88-90 CALEB STREET

CITY OF PORTLAND, MAINE
Application for Permit to Install Wires

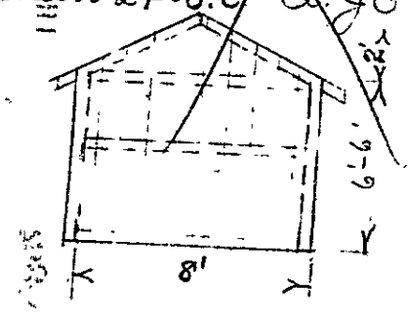
11/16/33 - Staking out O.K. Rear wall has been made up in one section with studding horizontal + sheathing vertical. Miss Weston says that Mr. Comeau agreed to use vertical studding not more than 24" o.c. - A.J.J.
